Office Action Summary	Application No. 10/540,011	Applicant(s) BALTES ET AL.	
	Examiner RYAN J. WALTERS	Art Unit 4177

DETAILED ACTION

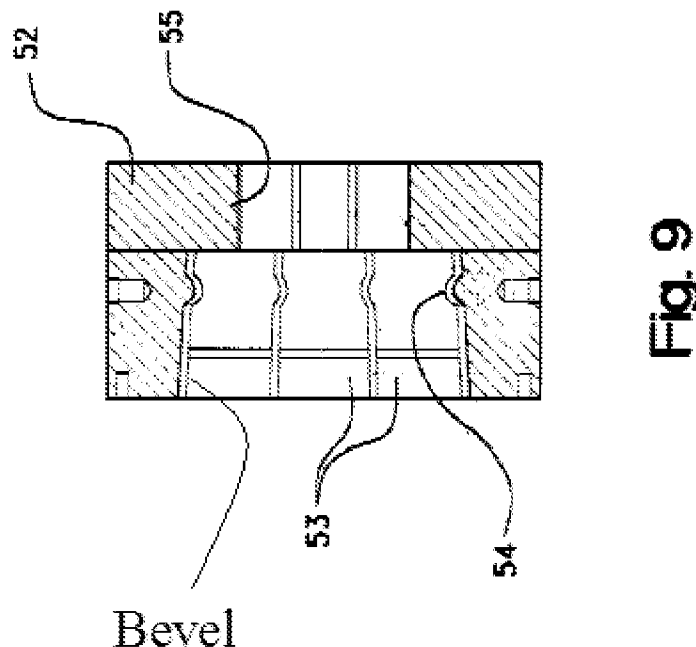
8. Claims 1 is rejected under 35 U.S.C. 102(b) as being anticipated by Bizak (U.S. Patent No. 2,734,531).

In regards to Claim 1, Bizak discloses a piston type accumulator having an accumulator housing, (“cylindrical casing”, Col. 4, lines 51-52, Fig. 1), and a freely slidable separating piston 48 (Fig. 1) which is displaceable in the longitudinal direction and which separates two working chambers. (Col. 1, line 53-55) Bizak further discloses the accumulator housing being sealed on each of the end sides by a cover component 15, 28 (Fig. 1) which are fastened to the accumulator housing by way of the free longitudinal edge 10 (Fig. 1) of the accumulator housing (See Col. 2, lines 31, Col. 2, line 43-45), by way of the threads 34 on the longitudinal edge 10 (Fig. 1), which for this purpose undergoes a positioning movement onto the cover component 15, 28.

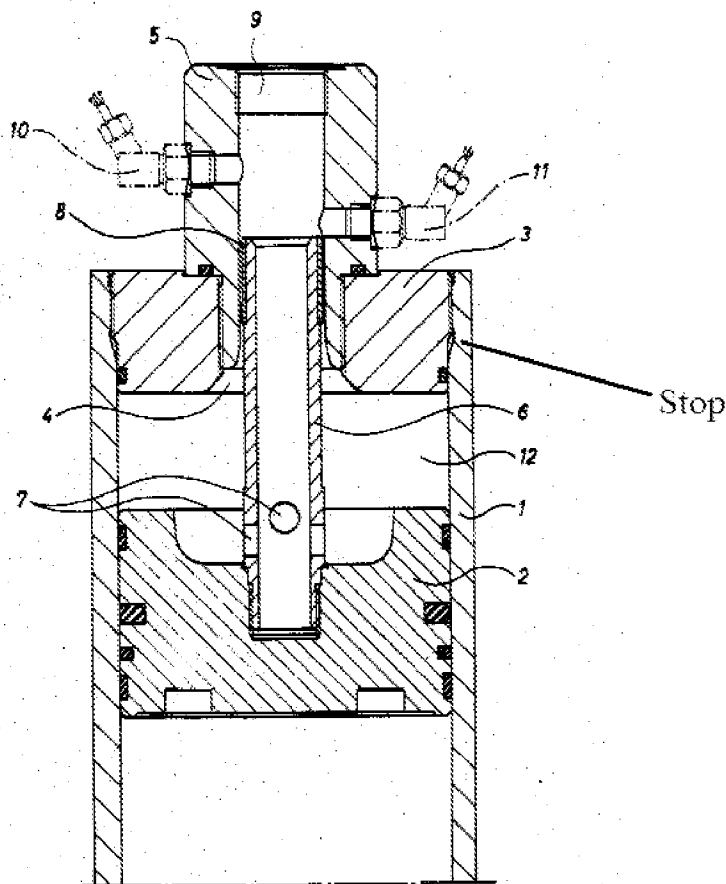
11. Claims 2, 6, and 10 are rejected under 35 U.S.C. 103(a) as being unpatentable over Rajabi in view of Audureau (EP 1,128,073).

In regards to Claim 2, Rajabi discloses all of the recited structure with the exception of one side of a cover component inserted into the accumulator housing so as to come to rest against a stop. However, Audureau teaches a cover component 2 (Fig. 1) inserted into the accumulator housing and coming to rest against a stop 25 (Fig. 1). The cover component 2 is retained in its end position by the clamping force of the positioned free

longitudinal edge 24 (Fig. 1). Therefore, it would have been obvious to one with ordinary skill in the art at the time the invention was made to combine the use of a stop as taught by Audureau with the invention disclosed by Rajabi for the purpose of ensuring that the cover component is placed into the desired location in relation to the accumulator housing.

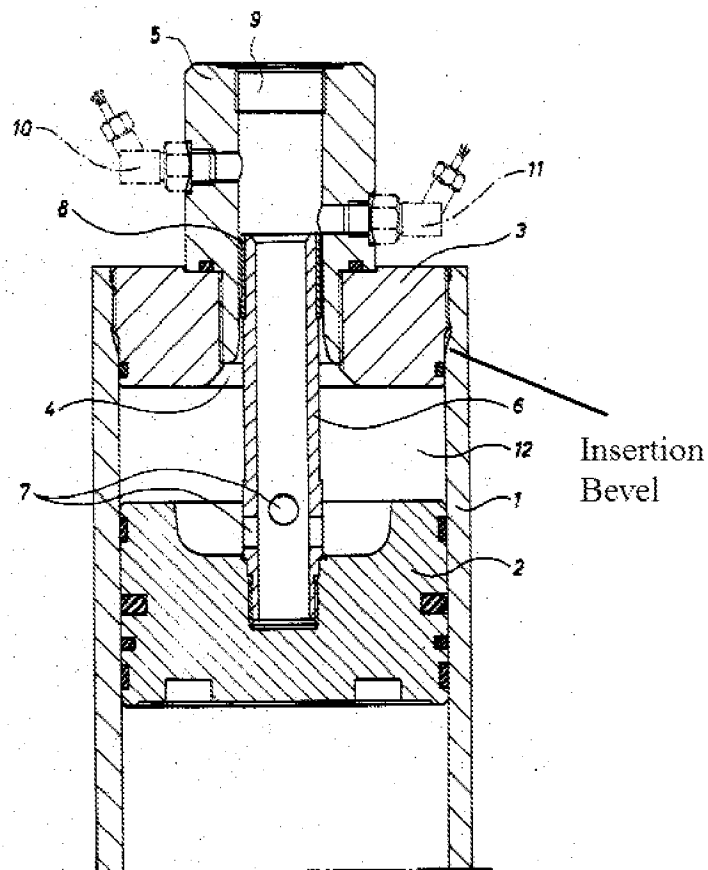
In regards to Claim 5, Rajabi discloses all of the recited structure with the exception of an insertion bevel on the longitudinal edge. Peter teaches an insertion bevel (See picture below; taken from sole Figure) on the longitudinal edge 1 (See sole Figure) which is facing the respective cover component 3 (See sole Figure) and toward the exterior. Therefore, it would have been obvious to one with ordinary skill in the art at the time the invention was made to include an insertion bevel as taught by Peter with the invention disclosed by Rajabi for the purpose of guiding the cover component into the accumulator housing in order to ensure proper installation of the cover component.
